PLANNING COMMISSION
SPECIAL MEETING AGENDA
March 7, 2023
7:00 P.M.

**Ditsch – Costco Site
1100 East Kemper Road
Application# 2023-0013
February 14, 2023**

DITSCH-COSTCO SITE
1100 EAST KEMPER ROAD
PLAN REVIEW APP #20230013
23020103
FEBRUARY 9, 2023

RE: Major Modification to PUD - Costco
Preliminary Plan – Ditsch USA LLC
AP 20230013

2 DOCKS & BLDG ELEVATION - LOOKING NORTH - FUTURE
1" = 30'-0"

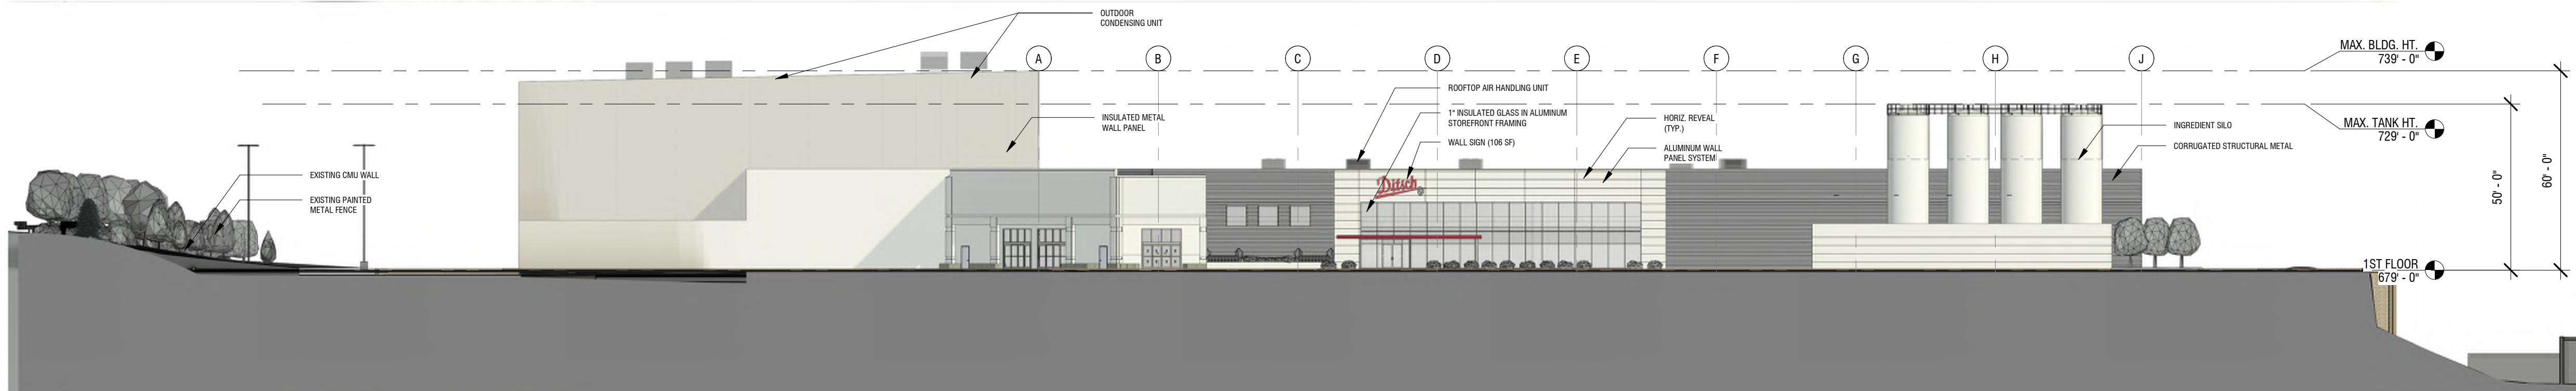
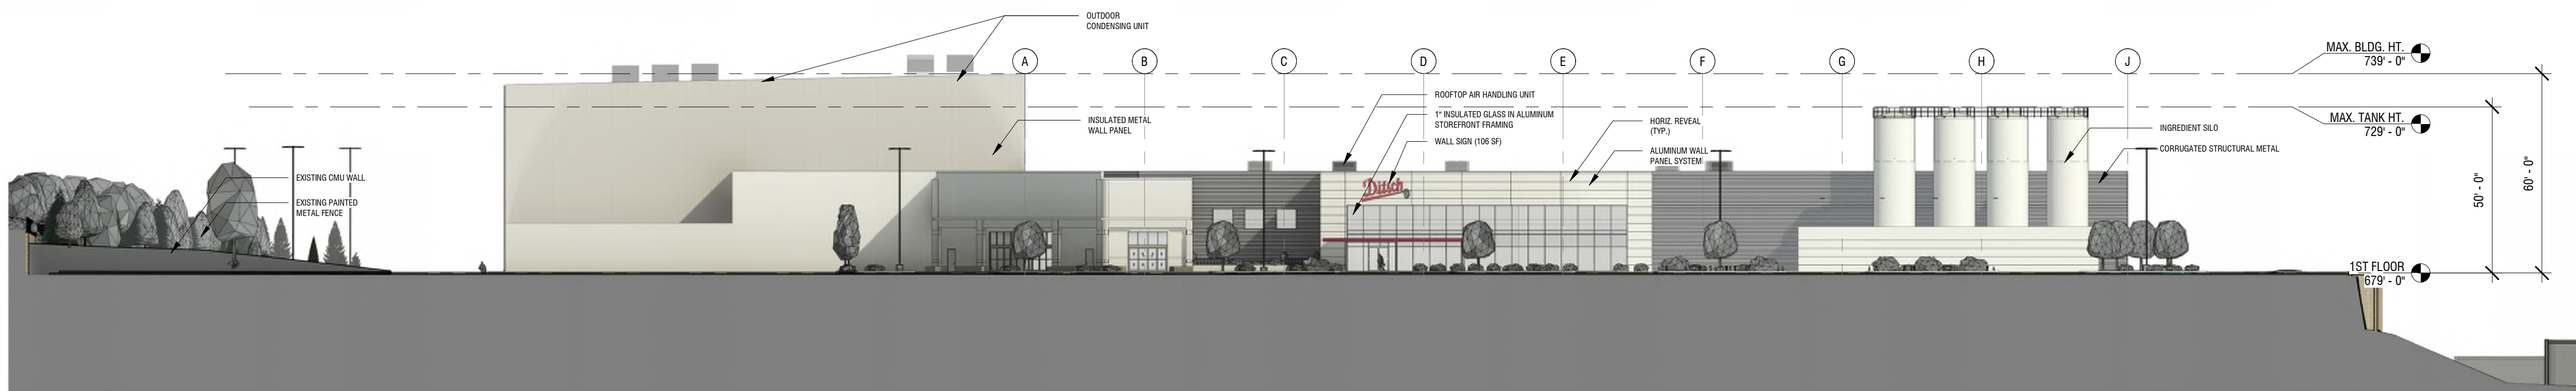
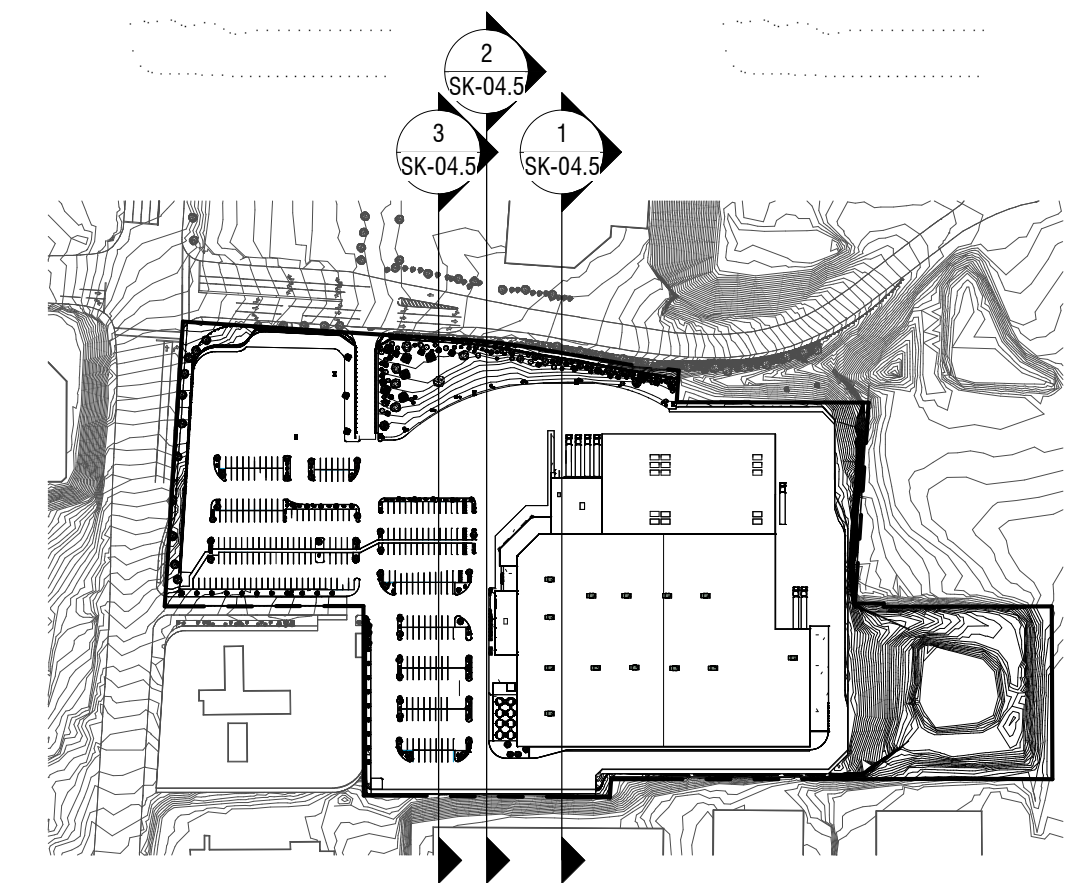
- 6) The proposed building addition on the west elevation is to be 60 feet tall which is permitted per Section 153.253 (F) with the Major Modification. The height of the proposed addition on the south elevation will be 30' 8" consistent with the existing building height.

- 7) Eight silos (50 feet in height) are proposed for the southeast corner of the building. The eight silos will be considered accessory structures per the definition contained in Section 153.600. As such, unless modified by Planning Commission and Council, they would need to comply with the provisions of Section 153.253 (E) (20) unless it is determined that unusual conditions exist per Section 153.253 (F) (3) (c). Section 153.253 (E) (20) requires the following relevant provisions for accessory structures:

Any mechanical equipment located at the top of the silos will need to be screened. All new roof, silo, or ground mounted equipment must be screened per the requirements of Section 153.254 (C). Screening details will need to be provided with the Final Development Plan.

front building elevation, and that the requirements of Section 153.303 (B) (1) are to be demonstrated to the greatest extent possible on the Final Development Plan. Any mechanical equipment on top of the silos is to be screened.

1 SK-04.6 SITE SECTION & BLDG ELEVATION - LOOKING NORTH - FUTURE
1" = 30'-0"

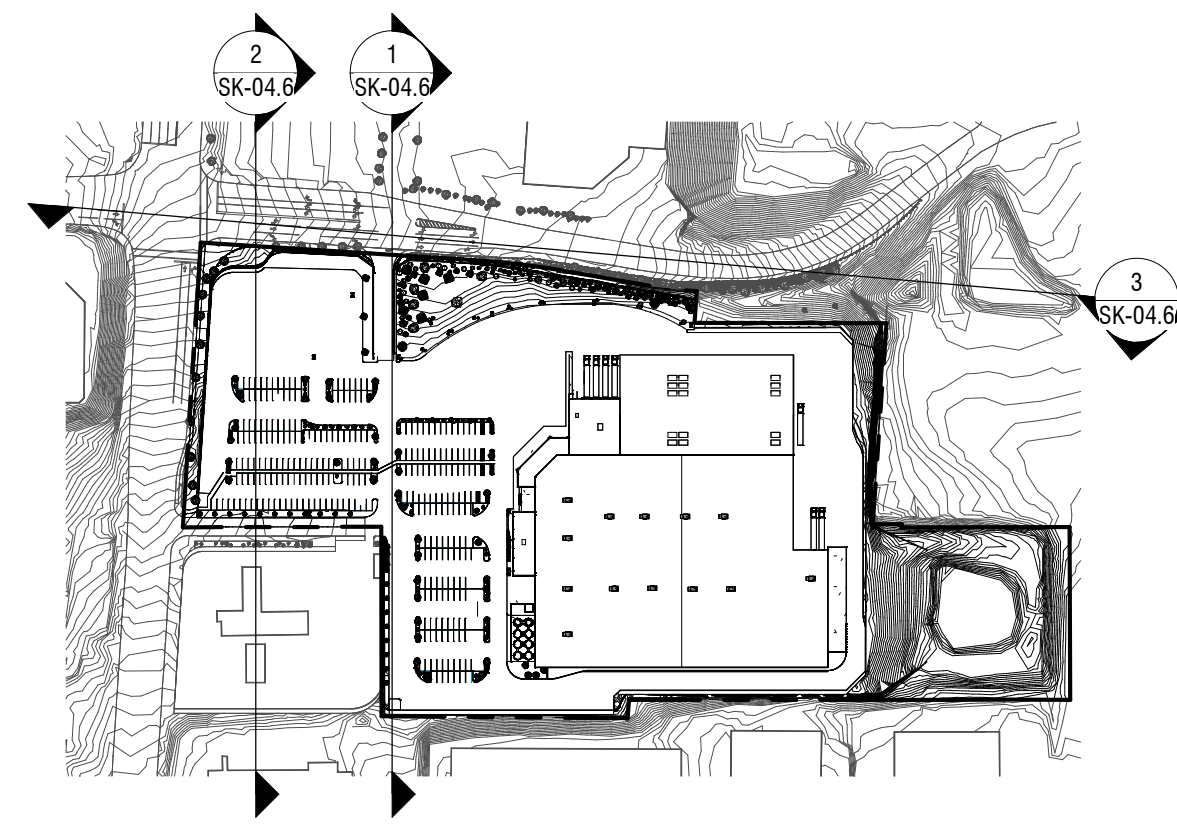
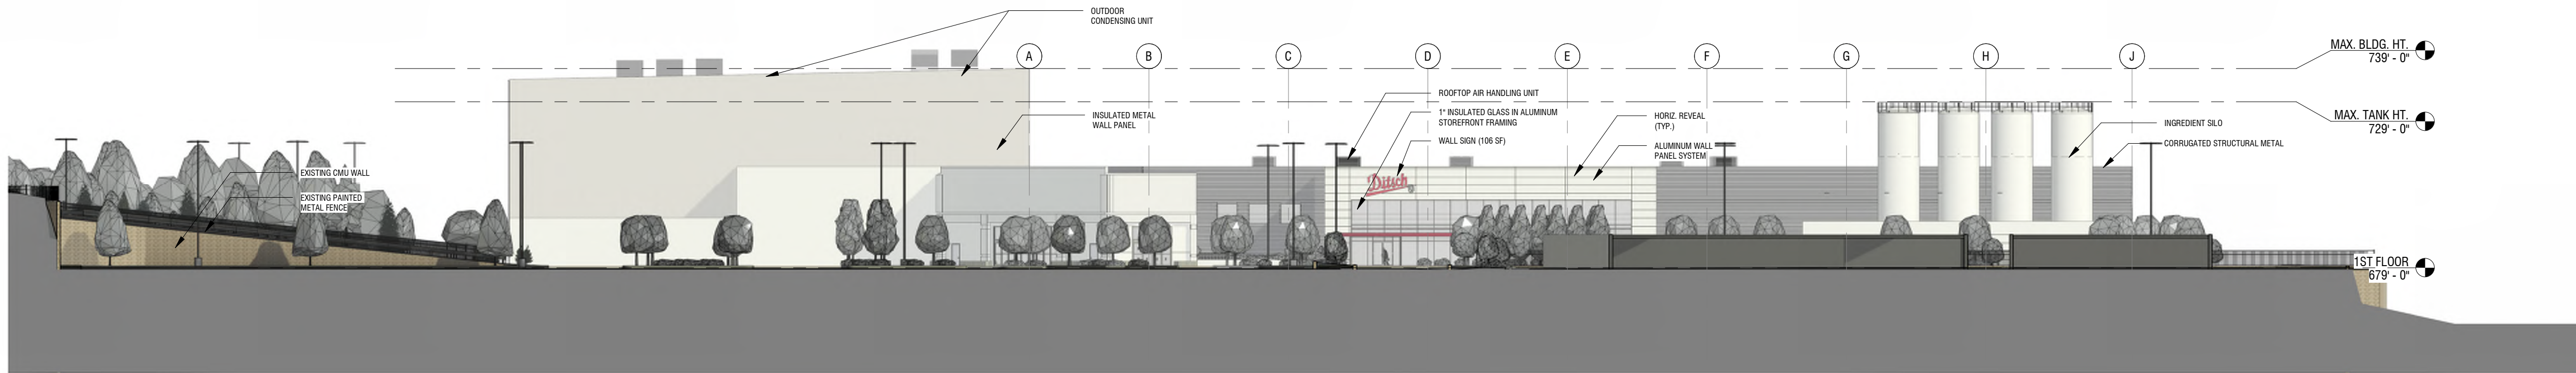
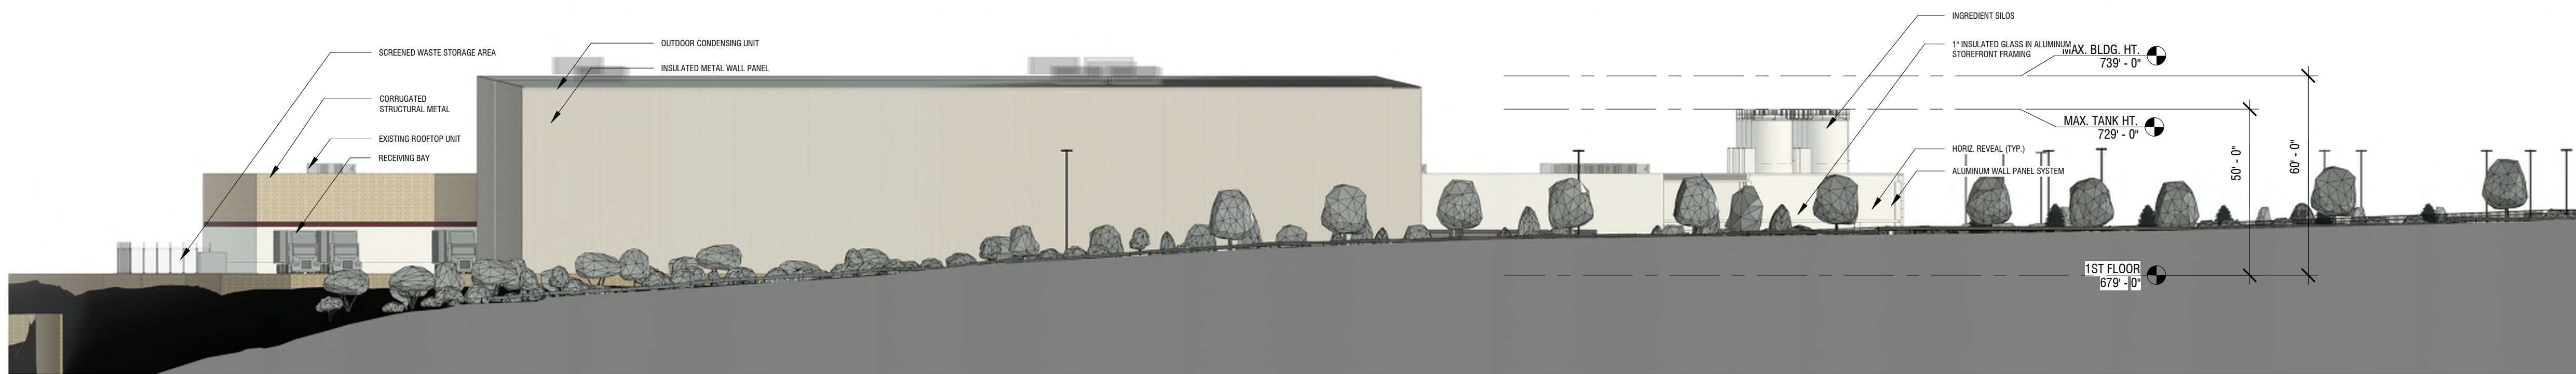
- 12) Bicycle parking is to be shown on the Final Development Plan as required per Section 153.302 (S).
- 13) The applicant indicates that there will be two screening walls located on the site. Walls, 14 feet tall with a finish to match the exterior of the building, are proposed to the south of the silos on the front elevation, and to the south of the loading dock on the west elevation to aid in screening of the uses. Planning Commission and Council will need to determine that the height of 14 feet, where a 10 foot wall is permitted, is warranted to maximize screening.

- 14) Planning Commission determine that unusual conditions exists, per Section 153.255 (F) (3) (c), and that the inclusion of 14 foot screen walls, exceeding the 10 feet in height permitted by Section 153.253 (E) (5), is appropriate.
